AENC-NG-CNS-REP-0371

# Norwich to Tilbury

**Document: 8.3.65 Signed Statement of Common Ground -  
Southfields Development Group - Tracked Changes Version**

**Planning Inspectorate Reference: EN020027**

Image 7.1 Interaction between TB259 to TB261, highlighted in pink is the inner consultation-zone of the Gas line, highlighted in blue is the outer consultation-zone and the Southfields development

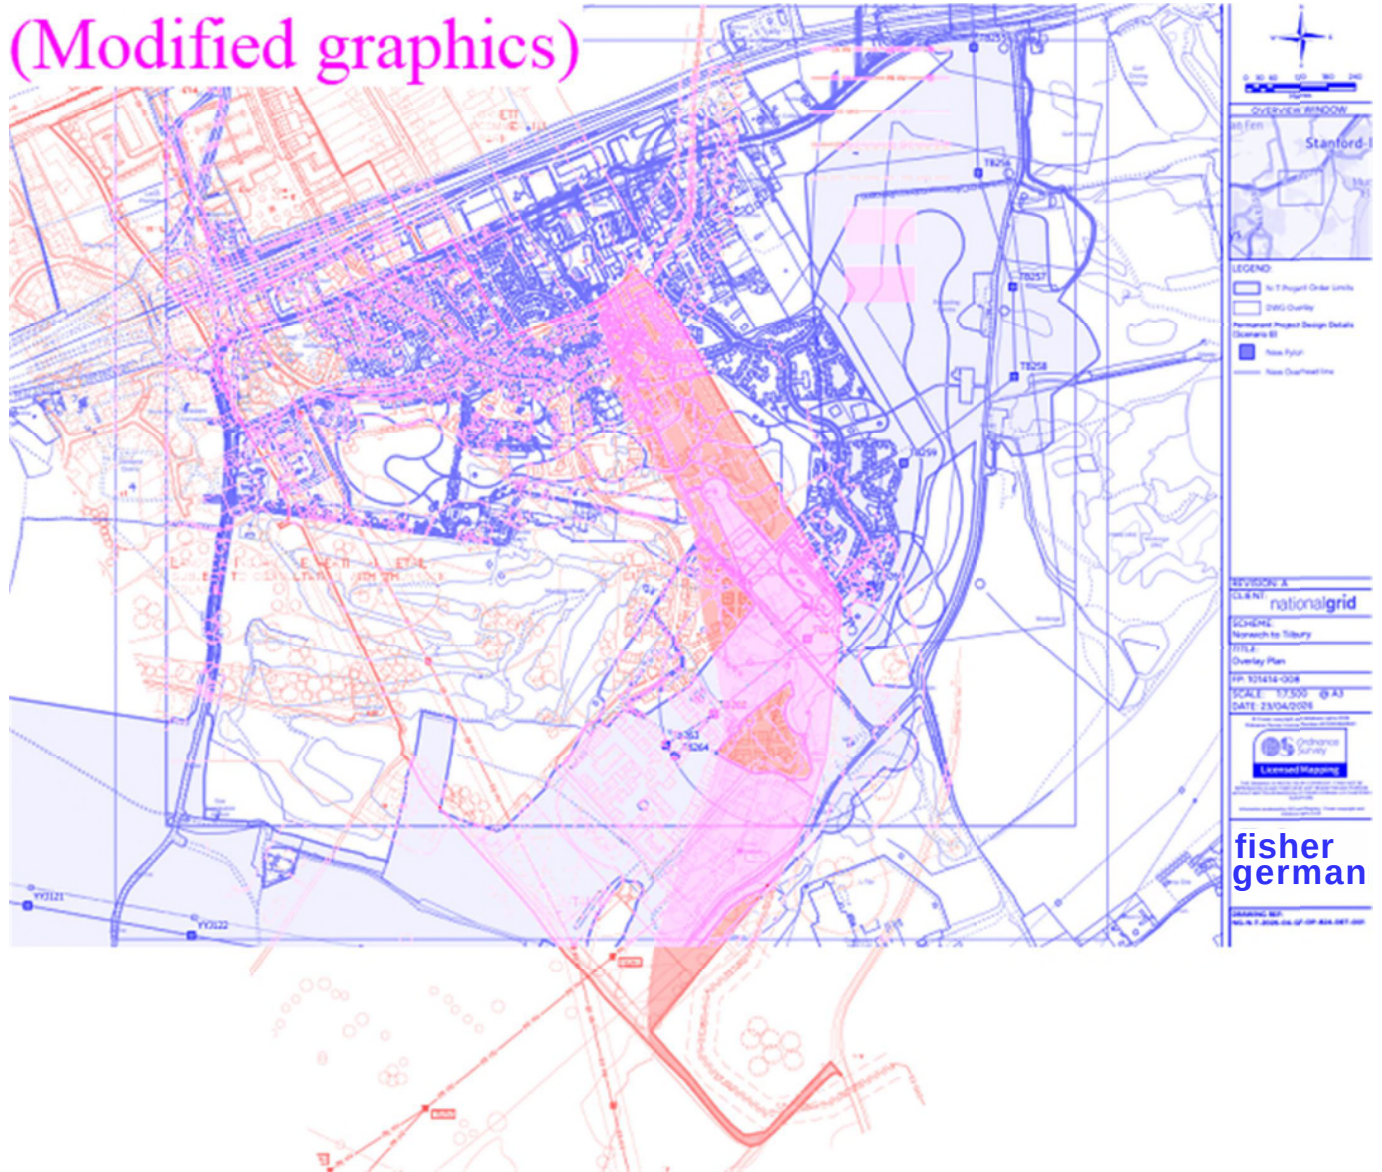
| <u>ID</u> | <u>Issue</u>                                                         | <u>National Grid position</u>                                                                                                                                                                                                                                                                                                                                                                                                                                                                                                                                                                                                                                                                                                                                                                                                                                                                                                                                                                                                                         | <u>Southfields Development Group position</u>                                                                                                                                                                                                                                                                                                                                                                                                                                                                                                                                                                                                                                                                                                                                                                                                                                                                                                                                                                                                                                                                                                                  |
|-----------|----------------------------------------------------------------------|-------------------------------------------------------------------------------------------------------------------------------------------------------------------------------------------------------------------------------------------------------------------------------------------------------------------------------------------------------------------------------------------------------------------------------------------------------------------------------------------------------------------------------------------------------------------------------------------------------------------------------------------------------------------------------------------------------------------------------------------------------------------------------------------------------------------------------------------------------------------------------------------------------------------------------------------------------------------------------------------------------------------------------------------------------|----------------------------------------------------------------------------------------------------------------------------------------------------------------------------------------------------------------------------------------------------------------------------------------------------------------------------------------------------------------------------------------------------------------------------------------------------------------------------------------------------------------------------------------------------------------------------------------------------------------------------------------------------------------------------------------------------------------------------------------------------------------------------------------------------------------------------------------------------------------------------------------------------------------------------------------------------------------------------------------------------------------------------------------------------------------------------------------------------------------------------------------------------------------|
| 9.1       | <u>Pylon-Positions Route alignment, pylon positions and oversail</u> | <p>The Applicant acknowledges Southfields Development Group's concerns regarding the alignment of the proposed overhead line and its potential interaction with the village and wider regeneration proposals.</p> <p>Throughout the design process, the Applicant has sought to identify an alignment that minimises impacts where practicable. In particular, efforts have been made to keep the overhead line as close as possible to the existing gas pipeline corridor, thereby limiting the extent of additional land affected and consolidating infrastructure where feasible.</p> <p>However, there are a number of technical and environmental constraints that limit flexibility in this location. Due to local topography and ground conditions, it has not been possible to route the line across the landfill. These constraints significantly restrict the range of alignment options in this area.</p> <p>With regard to tower position TB261, its location has been determined through detailed engineering design, including span</p> | <p>theThe 'line' presently shown as running across the southern part of the 800 dwelling village site, and the Thurrock Council owned filled refuse tip, which is to the immediate east of the village site, blight the whole of the village site to the point of making the proposed dwellings unsaleable, in addition the agreement for Thurrock Council and National Grid to jointly participate in regeneration of the 80 acre filled tip area would also be prejudiced by the presently proposed positions of two of the new pylons and the proposed pylon line.</p> <p>Prima facie it looks as if the new pylon cable line could continue further south along the east side of Buckingham Hill Road to cross the BHR just to the south of the junction of Holford Road with the Buckingham Hill Road. The latter line would remove the blighting effect upon the proposed village site and the regenerated for recreation purposes Buckingham Hill Road 'Council owned refuse tip, while occupying land which is presently vacant and unlikely to ever be considered for residential development.</p> <p>I cannot see any material difference in the</p> |

| <u>ID</u> | <u>Issue</u> | <u>National Grid position</u>                                                                                                                                                                                                                                                                                                                                                                                                                                                                                                                                                                                                                                                                                                                                                                                                                                                                                                                                                                                                                                                                             | <u>Southfields Development Group position</u>                                                                                                                                                                                                                                                                                                                                                                                                                                                                                                                                                                                                                                                                                                                                                               |
|-----------|--------------|-----------------------------------------------------------------------------------------------------------------------------------------------------------------------------------------------------------------------------------------------------------------------------------------------------------------------------------------------------------------------------------------------------------------------------------------------------------------------------------------------------------------------------------------------------------------------------------------------------------------------------------------------------------------------------------------------------------------------------------------------------------------------------------------------------------------------------------------------------------------------------------------------------------------------------------------------------------------------------------------------------------------------------------------------------------------------------------------------------------|-------------------------------------------------------------------------------------------------------------------------------------------------------------------------------------------------------------------------------------------------------------------------------------------------------------------------------------------------------------------------------------------------------------------------------------------------------------------------------------------------------------------------------------------------------------------------------------------------------------------------------------------------------------------------------------------------------------------------------------------------------------------------------------------------------------|
|           |              | <p>length, safety, and structural requirements. Relocating this tower outside of the refuse tip area is not feasible without exceeding acceptable span distances or necessitating additional infrastructure, which could result in greater overall environmental and visual effects.</p> <p><a href="#"><u>With regards to tower TB259, there are restrictions as to possible relocation due to the presence of a high-pressure gas main to the east of the proposed location.</u></a></p> <p>The Applicant notes the concerns raised in relation to the potential implications for the proposed development and has, to date, sought to take account of emerging master planning where reasonably practicable within the design process. However, given the constraints outlined above, there is limited scope for further modification to the alignment in this area.</p> <p>The Applicant remains committed to ongoing engagement with stakeholders and will continue to consider any reasonable opportunities to reduce effects where practicable <a href="#"><u>through detailed design.</u></a></p> | <p>construction cost to 'Grid of the overhead line as presently indicated, as against moving the 'line' to continue further south along the east side of Buckingham Hill Road. Given the height, substantial nature and position of the pylons and the 'line' as presently proposed, my proposed scheme for the new Southfields Village and a Country Park which will, all being well, include the regenerated refuse tip as referred to above, will not be viable.</p> <p>People do not like living near pylons and overhead lines and the incidence of the proposals as presently indicated, albeit over a very small length of the overall 'line', renders the ten years of work spent upon creating the new 'Village and Country Park, and obtaining local residents support, as completely wasted.</p> |
